SERVICE BULLETIN

REFERENCE AUDIO
NUMBER 007
DATE 08-04-89
MODEL AE,EL,MA,ST,SV,YR

INOPERATIVE CASSETTE PLAYER

CUTAWAY SIDE VIEW

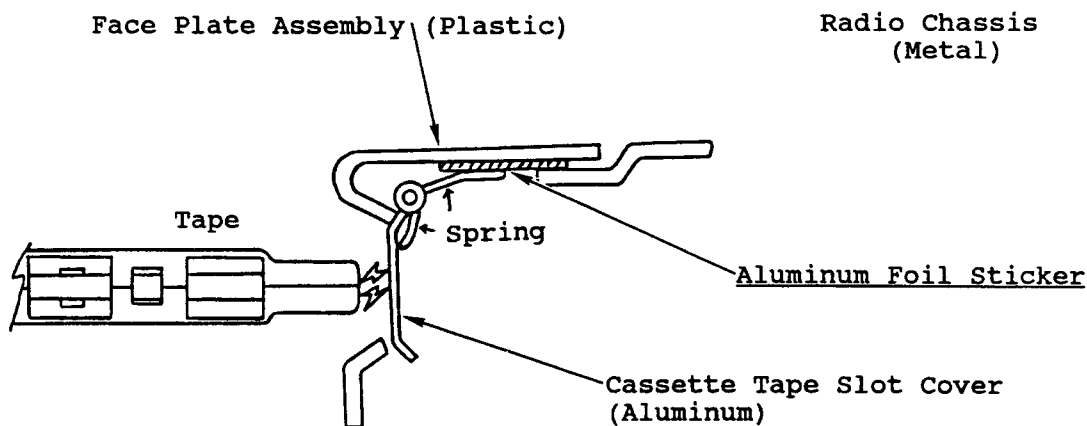
To prevent electrostatic discharge from disabling the cassette player, an aluminum foil sticker has been added to the inside of the face plate assembly. The sticker provides a pathway for the electrostatic discharge originating from a cassette to go directly to the audio chassis and avoid any damage to the printed circuit board and components.
